DATE: FEBRUARY 23, 2004
TO: CHAIRMAN AND MEMBERS OF THE PLANNING COMMISSION
FROM: EILEEN P. FOGARTY, DIRECTOR, PLANNING AND ZONING
SUBJECT: QUAKER VIEW (DSP # 2002-0032) (REZ # 2002-0004)

Docket Item #13 and 14
REZONING #2002-0004
DEVELOPMENT SITE PLAN #2002-0032
11-21 NORTH QUAKER LANE (QUAKER VIEW)

Planning Commission Meeting
March 2, 2004

Original Site Plan

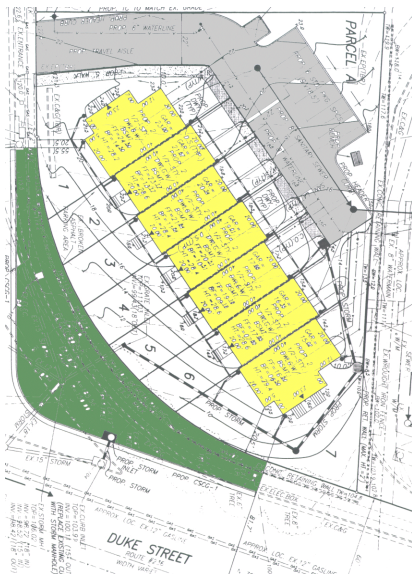
The original plan for this site proposed the removal of the existing free-flow or "hot-right" turning movement lane from westbound Duke Street to northbound North Quaker Lane. A dedicated right turn lane would have remained on Duke Street for the northbound turning movement. This proposal would have enabled additional open space, improved the pedestrian crossing while still providing a dedicated turn lane on North Slaters Lane, with a more traditional "T" intersection.

Input from the community and the nearby fire station on Duke Street (Station #207) indicated a desire to retain the existing "hot right" turning movement. From the Fire Department perspective, it was determined that the removal of the "hot right" turning movement could delay response time from the station to areas north of Duke Street and that a new 90-degree turning configuration could cause problems for the heavy fire apparatus in climbing the grade that exists on North Quaker Lane. The community raised the concern that the elimination of the "hot right" turn would cause delays for turning movements from Duke Street onto Quaker Lane.

In order to address these areas of concern, the applicant revised the site plan to reflect the current retention of the free right. To address concerns regarding access to the site, T&ES staff has recommended the extension of the existing Quaker Lane median to the north, to prevent left turns into and out of the site. Staff is also recommending improvements to signage and crosswalks in the immediate area to improve pedestrian and vehicle movement surrounding the site. Despite the applicant's modification to address the community's desire to retain the "hot right," some citizens still have concerns about the safety of the entrance and an overall concern of traffic impacts of developments in this general area.
